Title: High-resolution Antarctic sea-ice thickness and snow depth from drift-aware multi-mission altimetry

5 Reviewer 2 - global comment

Answers to Reviewer 2 : specific comments

Figure 1. Illustration of the IS-2 points where the sea-ice drift has been interpolated or extrapolated. The highlighted zone is the area between 15 % and 70 %.

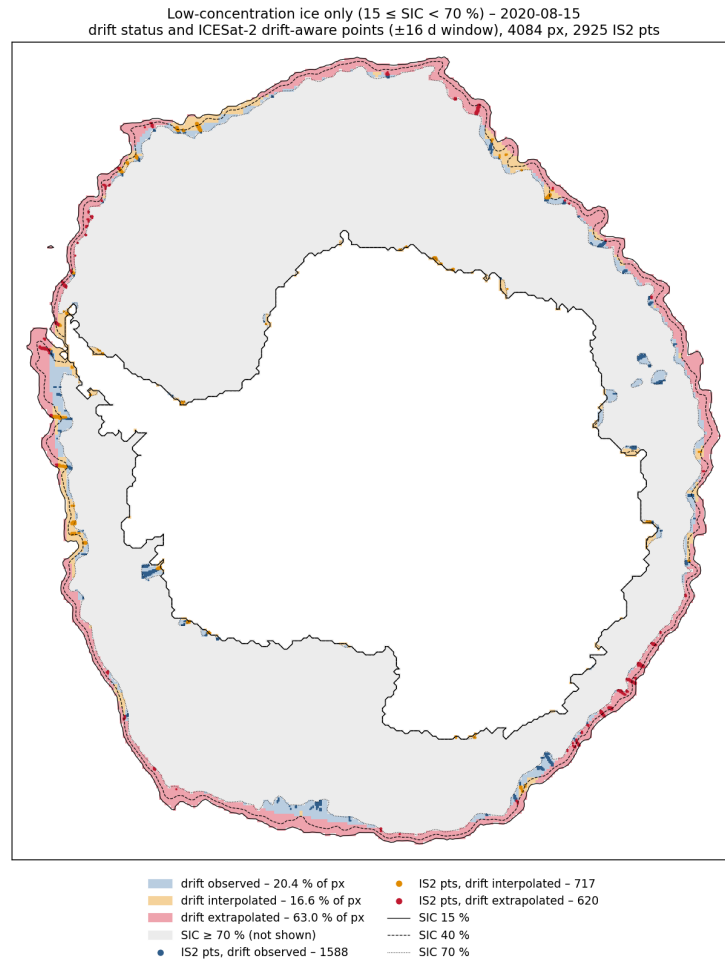
Line 127: Is there any issue with only using coverage where SIC > 40% vs IS-2 with the drift correction? What happens between SIC 40% and 15%?

The drift products (OSI-455/435) provide no vectors below about 40 % SIC, but almost all ICESat-2 parcels lie above this threshold: only 0.2 % of the parcels are at 15–40 % SIC on 15 August 2020, and 6.5 % on 15 February 2020. Between 40 % and 15 % SIC, the parcels are kept and still drift-corrected. The drift is interpolated or extrapolated between the nearest valid vectors when a valid parcel has been created outside of the 15-40% area. We added a sentence to tackle this point in the corresponding paragraph in the revised manuscript. The following figure 1 supports this statement for the 15th of August 2020.

Figure 2. Schematic of the processing chain.

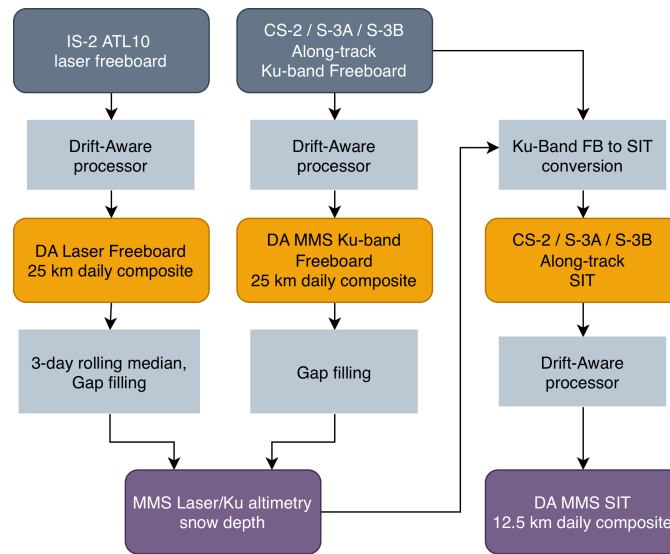
The methodology summary in Section 2.6 may be elevated with a flow-chart style schematic to provide visual explanation of the processing chain.

We thank the reviewer for this suggestion. We agree that the processing chain is relatively complex and could benefit from a more visual overview. We have therefore added a schematic workflow summarizing the main processing steps from the satellite observations to the final MMS sea-ice thickness and snow-depth products. The flow-chart in the following figure has been added to the manuscript.

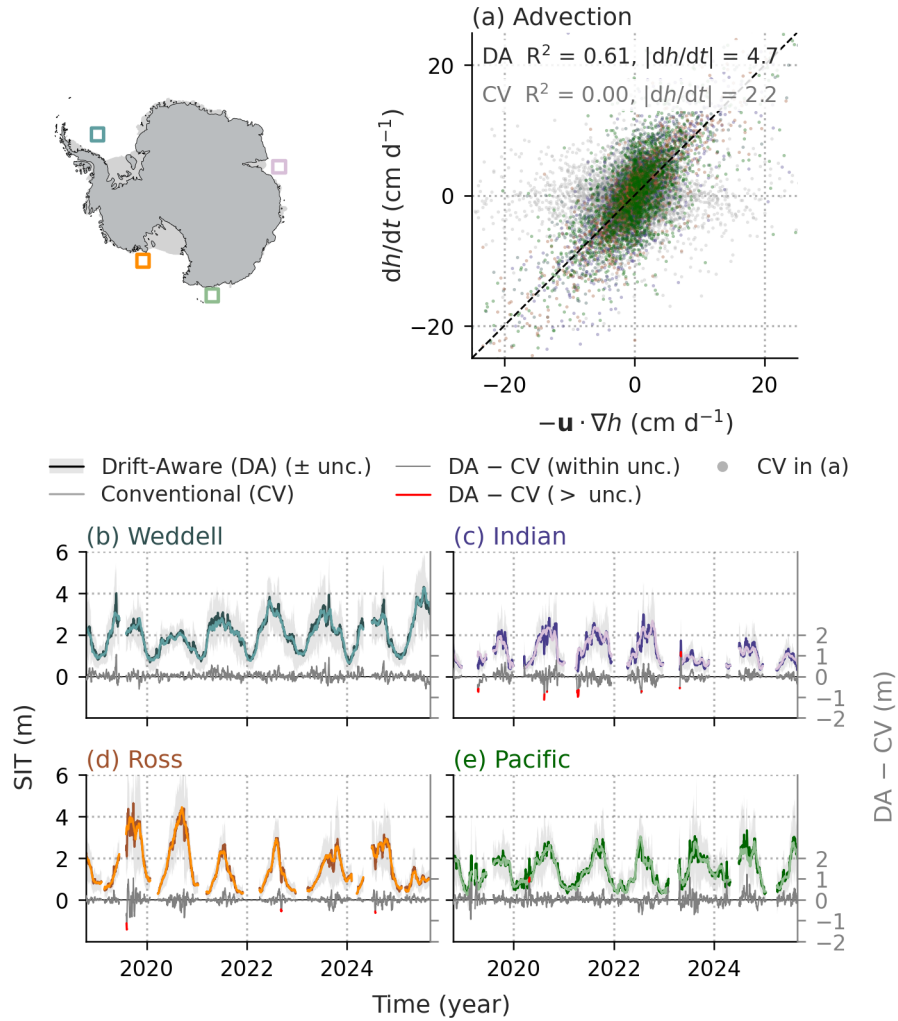
320 **Figure 10 analysis: Some interpretation provided does not accurately reflect what is displayed in the figure.**

Line 488: This is not the case in the figure, drift-aware variability looks like it occurs more when the SIT change slows down, i.e. at the peaks.

325 **Line 494: Figure 10 does not seem to directly indicate an improvement using MMS, moreover MMS captures more variability. There is no evidence provided here to trust this temporal variability and therefore this figure alone cannot be used claim an improvement. This needs re-writing. This also propagates into Line 531 in Section 6.**

330 *We thank the reviewer for these comments. We agree that the original wording was too strong. Figure 10 shows that the drift-aware and conventional approaches can produce different representations of temporal variability and, at times, differences that exceed the estimated uncertainty. However, the figure alone does not demonstrate that these differences necessarily correspond to an improvement. We have therefore revised the text accordingly and limited the interpretation to the impact of the gridding methodology itself.*

335 *In addition, Figure 10 has been revised (Fig. 3). We added a panel comparing the daily thickness change, dh/dt , with the thickness change expected from advection by the ice drift, $-\mathbf{u} \cdot \nabla h$, computed from the OSI SAF ice drift (OSI SAF and EUMETSAT SAF On Ocean And Sea Ice, 2022; Lavergne and Down, 2023). The daily changes are about twice as large in the drift-aware product as in the conventional one, and are largely explained by advection ($R^2 = 0.61$, vs. 0.00 for the conventional product). The additional variability is therefore consistent with the transport of thickness features by the ice drift. As the drift-aware method itself uses ice drift, we do not present this as an independent validation but as a property of the gridding method. The text at Lines 488, 494 and 531 has been revised accordingly.*

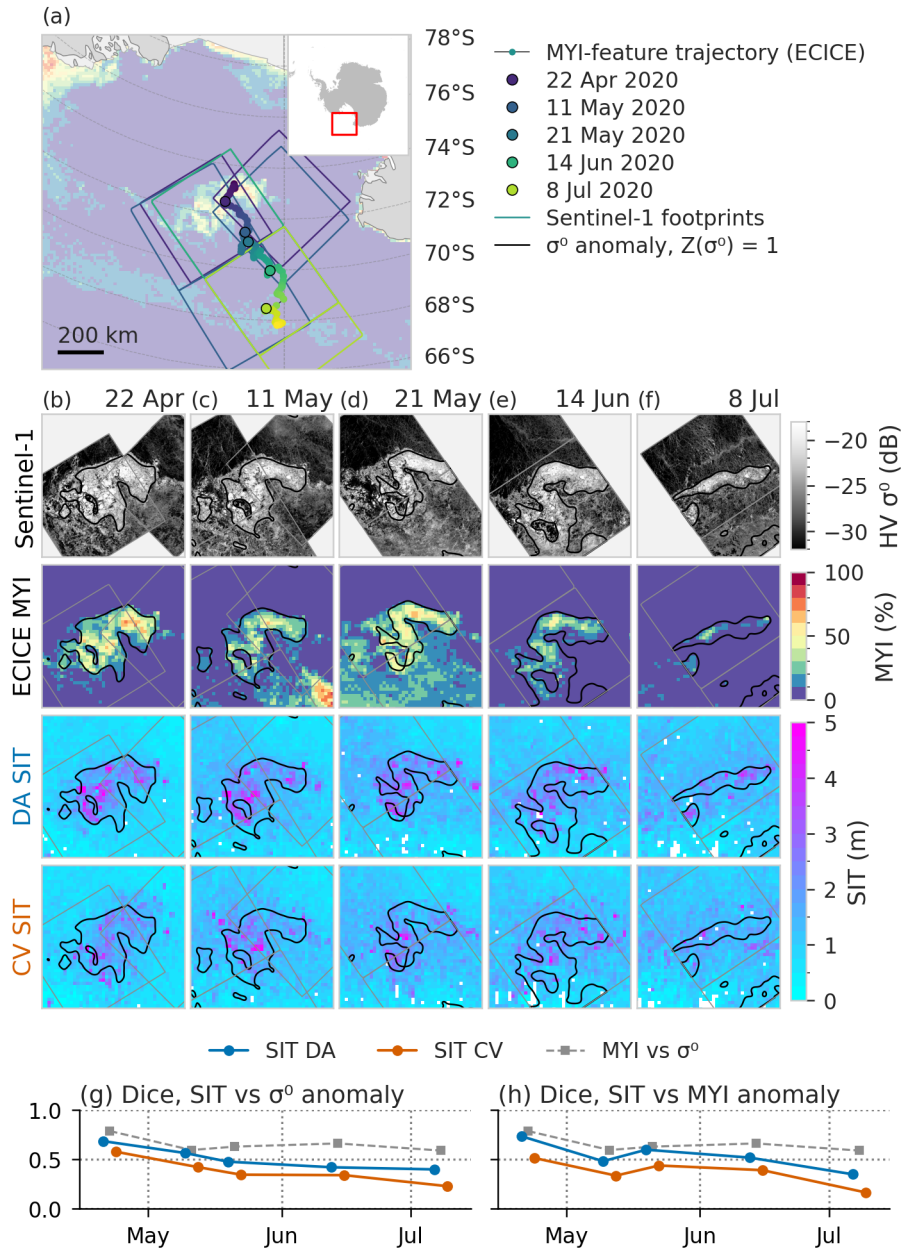
Section 5.2 must be expanded to a full quantitative treatment, e.g. passive microwave snow depth. This is critical for this paper as it justifies the entire concept. After doing so, this should be promoted into results Section 3. [major corrections]

345 *We thank the reviewer for this suggestion. We agree that the impact of the drift-aware processing should be assessed more quantitatively. Rather than relying solely on the qualitative comparison shown in Section 5.2, we now include quantitative spatial metrics (called Dice) and move this analysis earlier in the Results section. This allows the benefits and limitations of the drift-aware approach to be established before the subsequent product intercomparison and evaluation sections. We focus on the MYI export event illustrated in Fig. 11 and track its evolution in both space and time. Note that this exported MYI event is the most significant one observed during the study period and therefore provides an excellent case study for assessing the added value of the DA framework. To quantitatively assess the consistency between sea-ice thickness (SIT), SAR backscatter (σ_0), and MYI fraction, we first standardized each variable to make them directly comparable despite their different units and dynamic ranges. We then identified regions characterized by enhanced values ($Z \geq 1$) and computed the Dice coefficient between the corresponding binary masks.*

350 *The Dice coefficient quantifies the spatial overlap between two datasets and is defined as:*

355 *$$\text{Dice} = 2|A \cap B| / (|A| + |B|)$$*

where A and B represent the regions with standardized values greater than or equal to one. A Dice coefficient of 1 indicates perfect overlap, while a value of 0 indicates no overlap. This metric therefore provides an objective measure of the degree to which the spatial structures identified in the SIT fields coincide with those visible in the SAR backscatter and MYI fraction fields.

360 The main results of figure 11 have been replaced by the following figure 4 and remaining findings corresponding to coastal ice will be place in the appendix:
